Thank you for guiding the review of our manuscript entitled " Evaluation of the hyperspectral radiometer (HSR1) at the ARM SGP site" (doi: 10.5194/amt-2023-115).

Reviewer #1

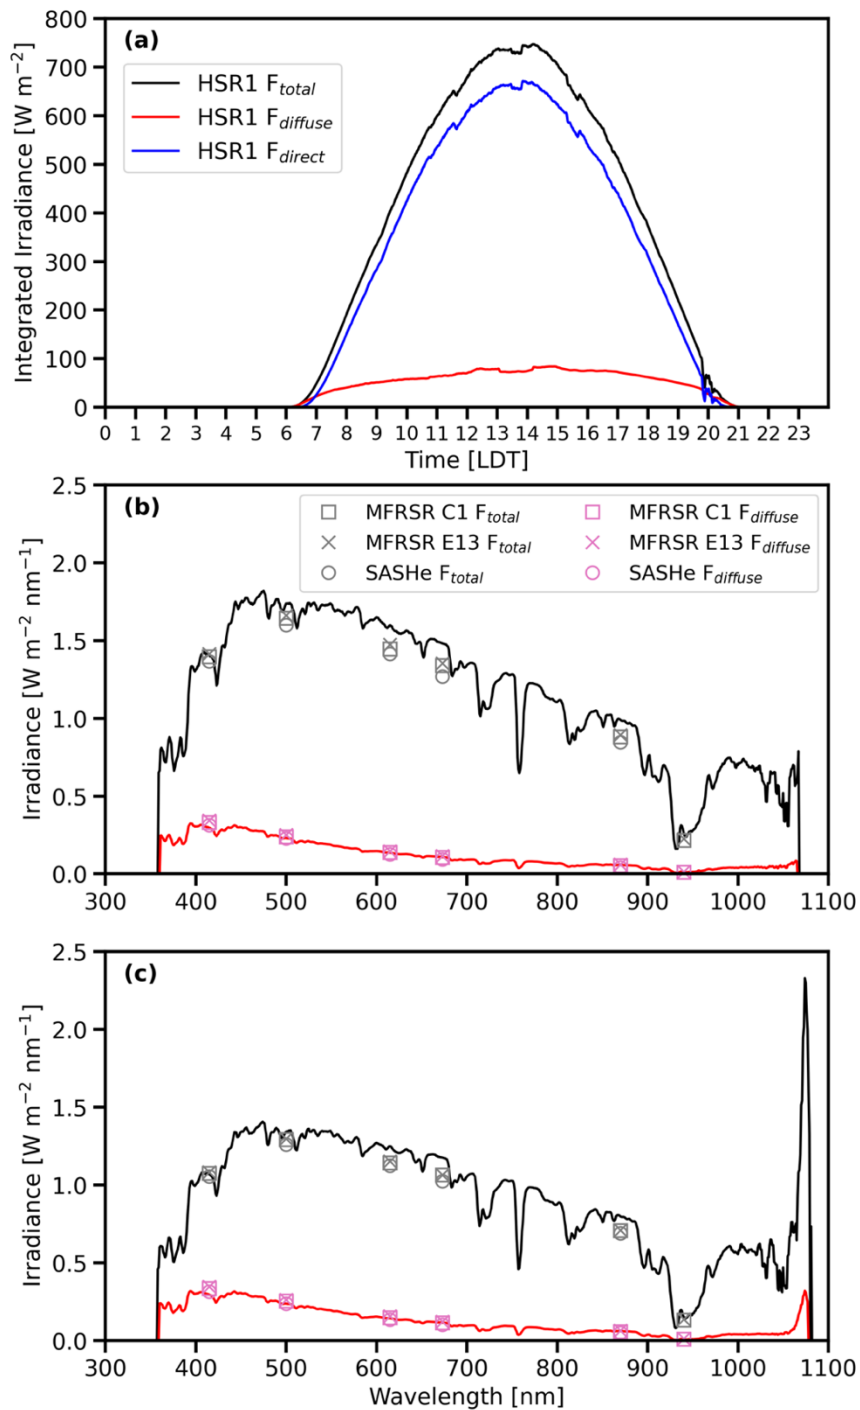
3. Fig. 2: Use a legend for “Collocated  $F_{total}$  (gray) and  $F_{diffuse}$  (pink) from the MFRSR C1 (square), MFRSR E13 (x-mark), and SASHe (circle)”

Thank you for the suggestion. We have revised Figure 2 by adding in a legend that includes MFRSRs and SASHe information. See revised Figure 2 below.
